BID ADDENDUM NO.1

2181539 Bank on Buffalo, Niagara Falls, NY

There was an error during the printing process that caused the structural & HVAC items to not appear in the Architectural drawings. Some of the drawings being replaced are only to show the missing items for clarification. No actual changes are occurring on these sheets. Any changes to the drawings are clouded & tagged.

A301

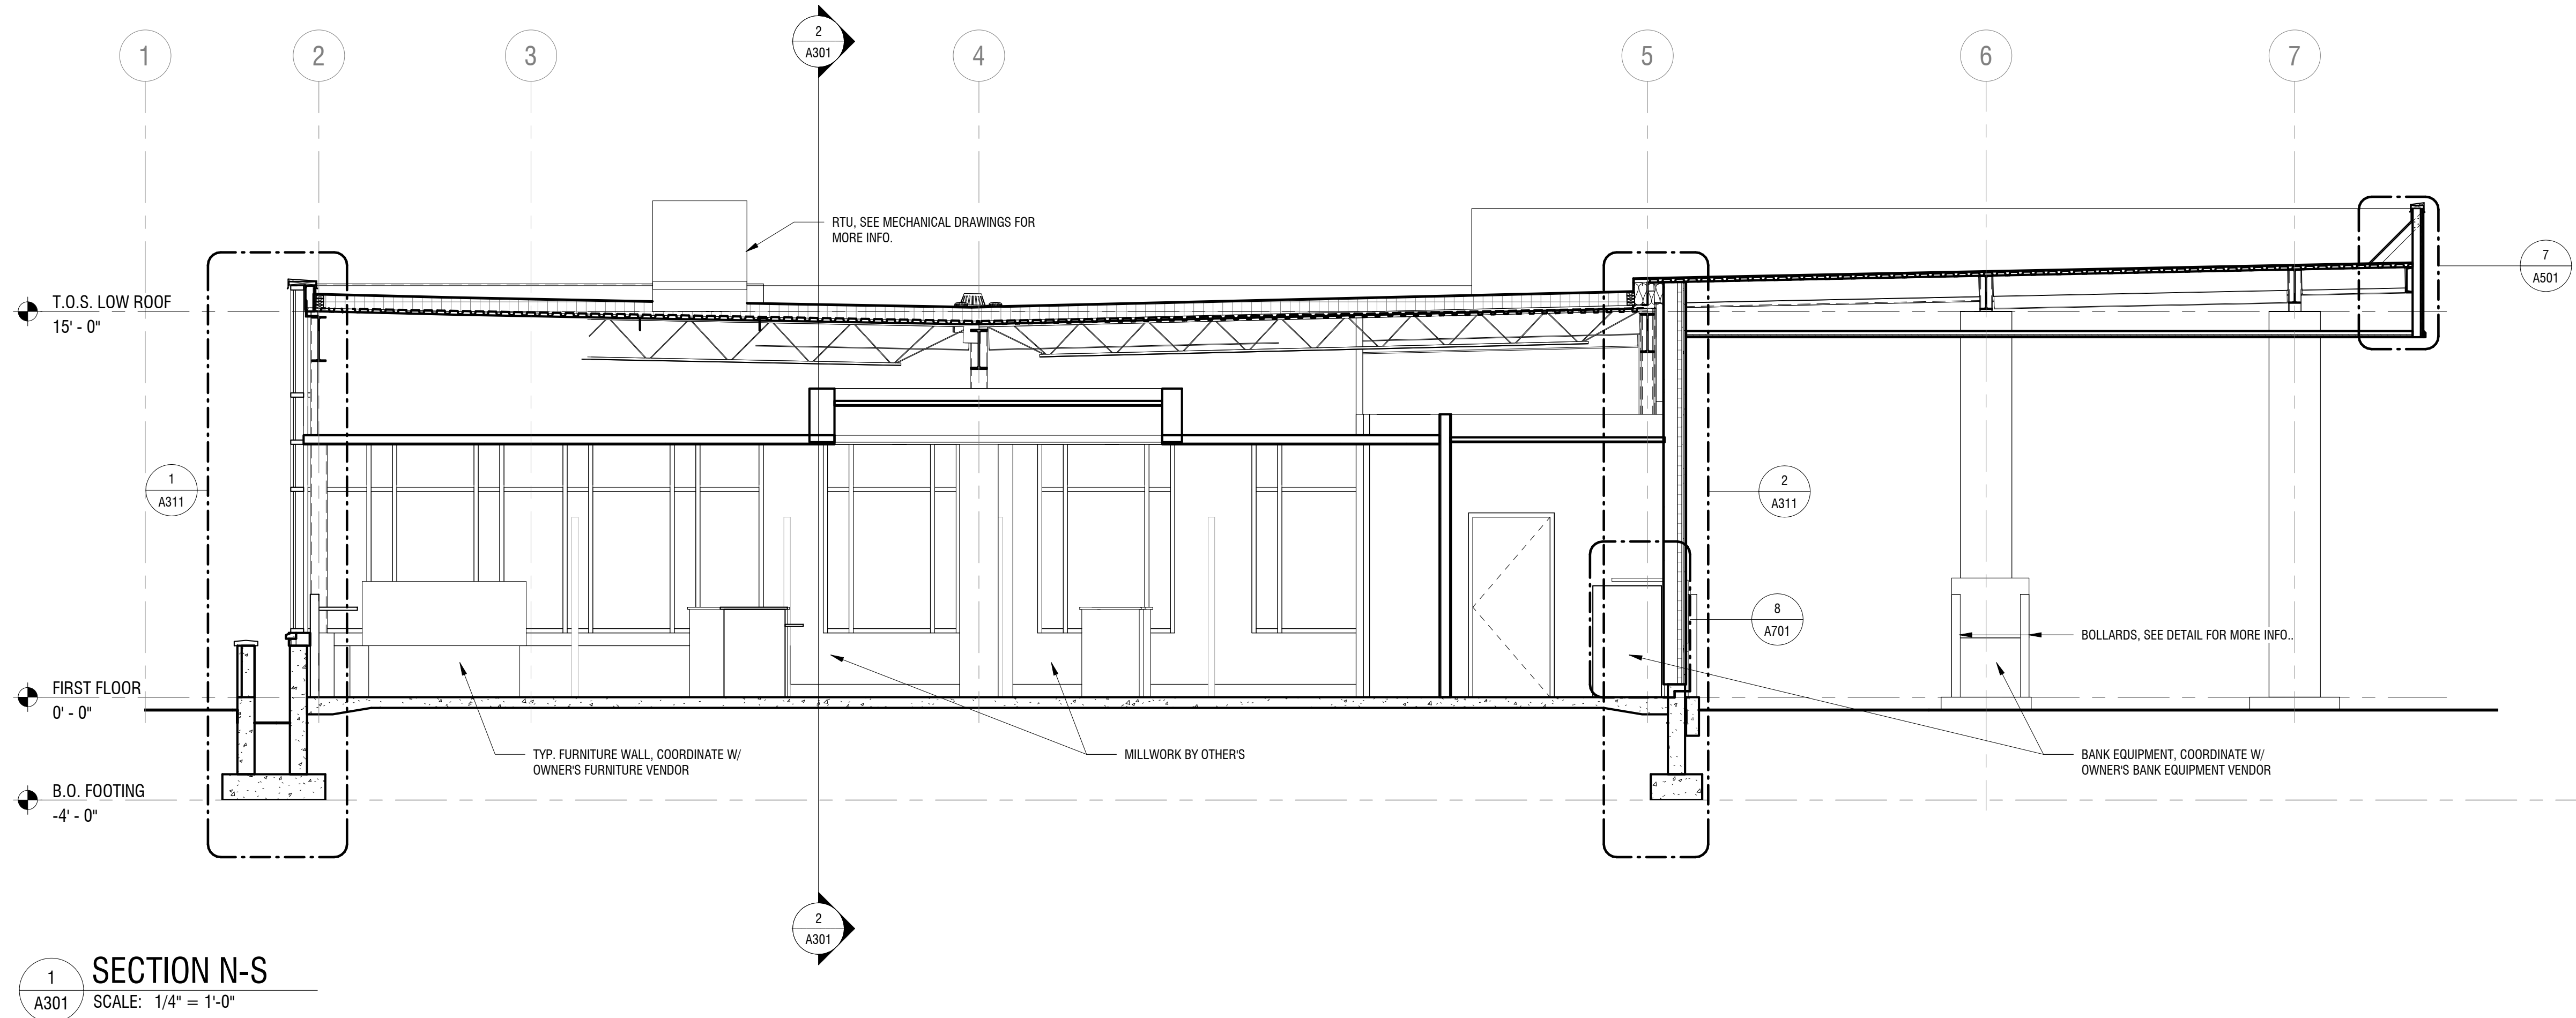
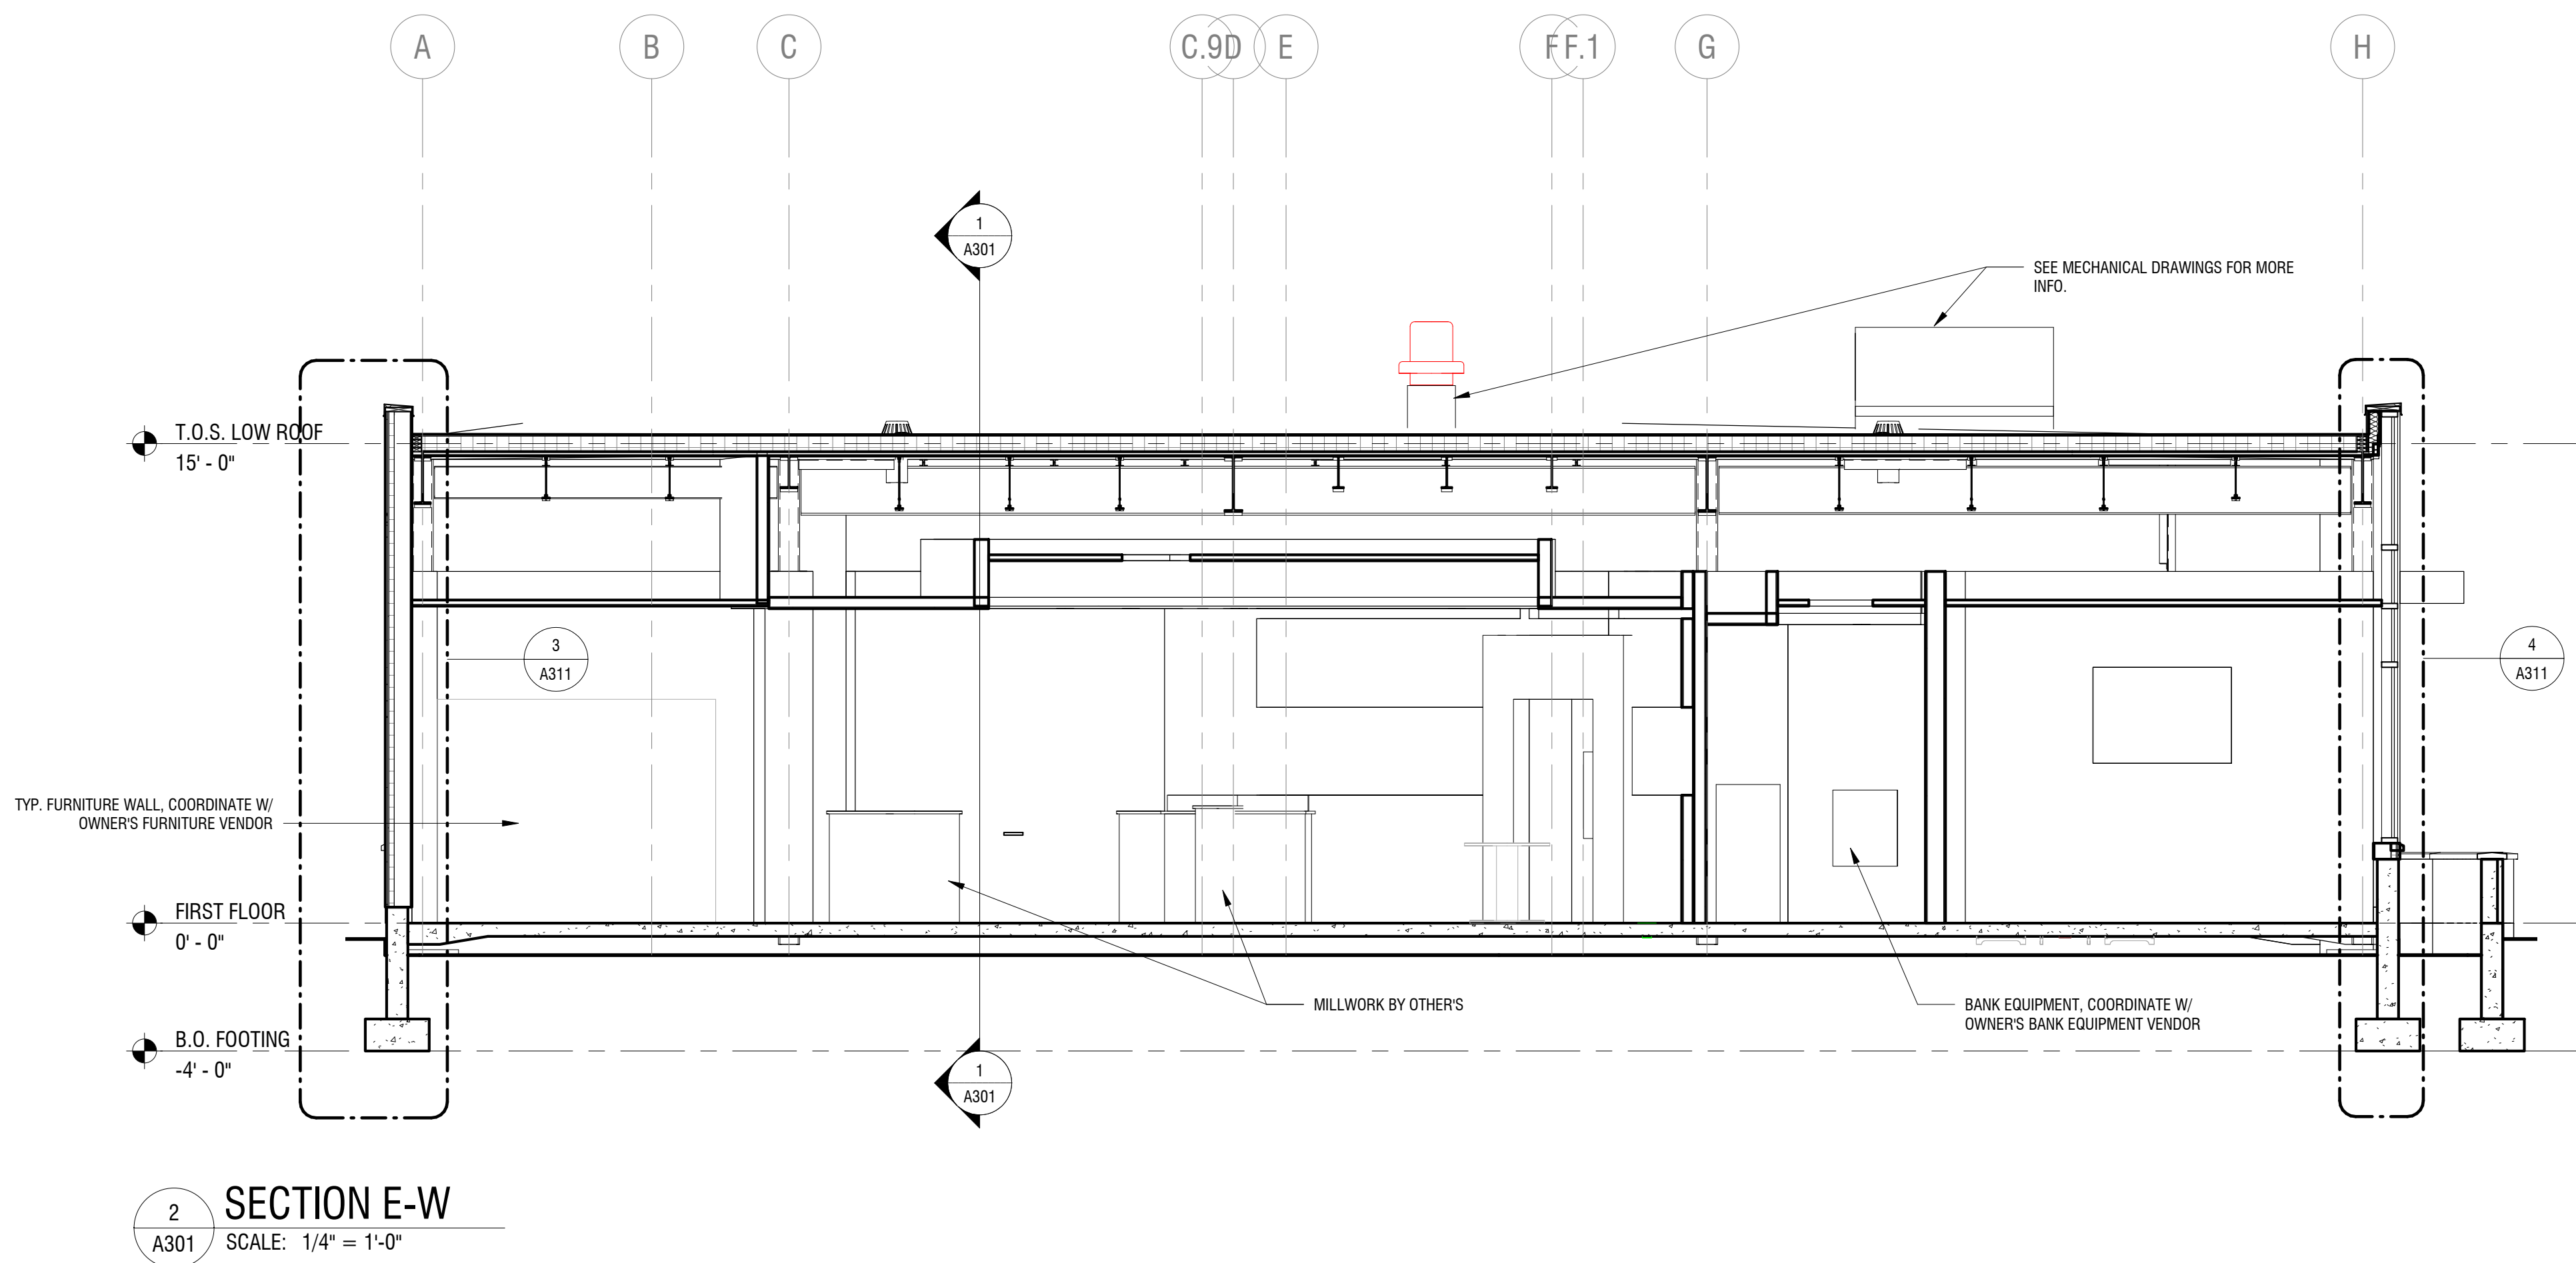
- H. Drawing A301**
 - 1. DELETE Drawing in its entirety
 - 2. ADD replacement Drawing A301
 - 3. HVAC & structural shown on drawings.
